Sub Region RTEP Mid-Atlantic Committee DPL Supplemental Projects

DPL-2021-001 Updated Scope

DPL Transmission Zone M-3 Process New Ring Bus Robinsonville – Rehoboth Line

Supplemental Project: s2947 (Need: DPL-2021-001, posted to 2023 DPL Local Plan)

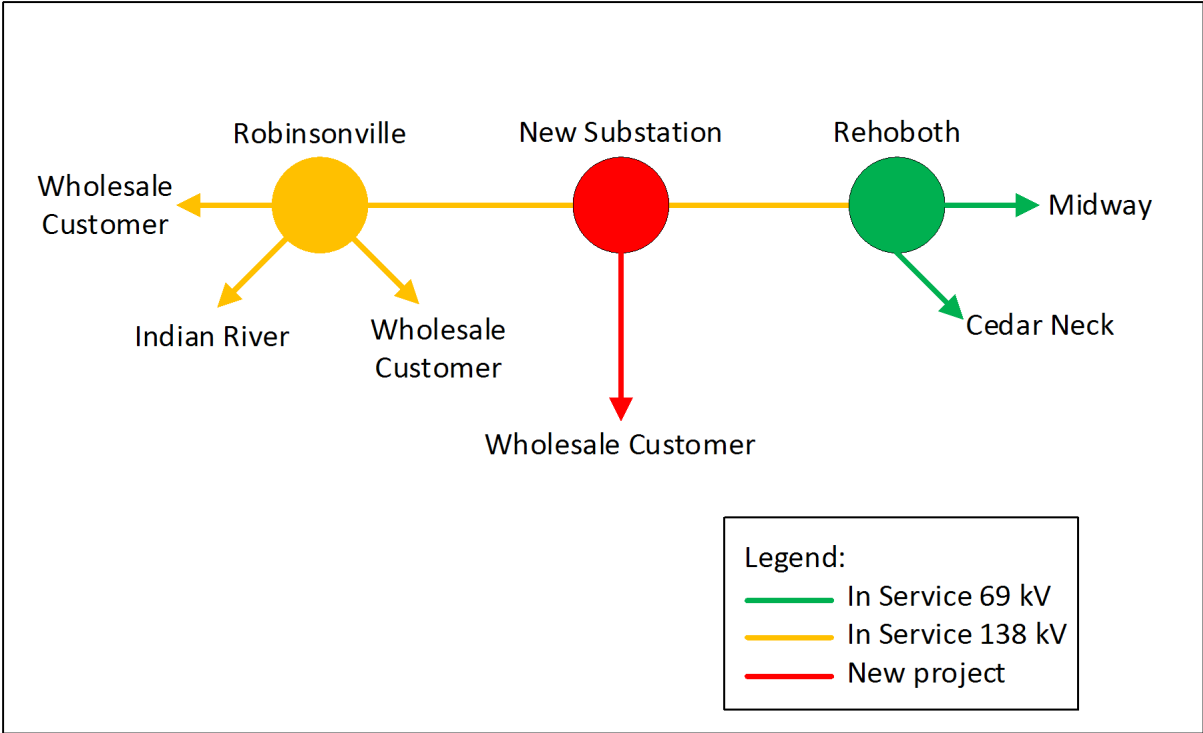
Problem Statement: Customer has requested a new 138 kV interconnection point off the Robinsonville – Rehoboth 138kV line due to load growth within the cooperative coupled with currently overloaded infrastructure.

Revised Scope: Construct a new 4-breaker ring bus substation with a capacitor bank tying into to the Robinsonville – Rehoboth 138kV line with a terminal position dedicated to the customer.

New Scope: Construct a new 4-breaker ring bus substation by tying into the Robinsonville – Rehoboth 138kV line with a StatCom for additional voltage support and provide a terminal position dedicated to the customer.

New Estimated cost: \$35M

New Projected In-Service: 2029
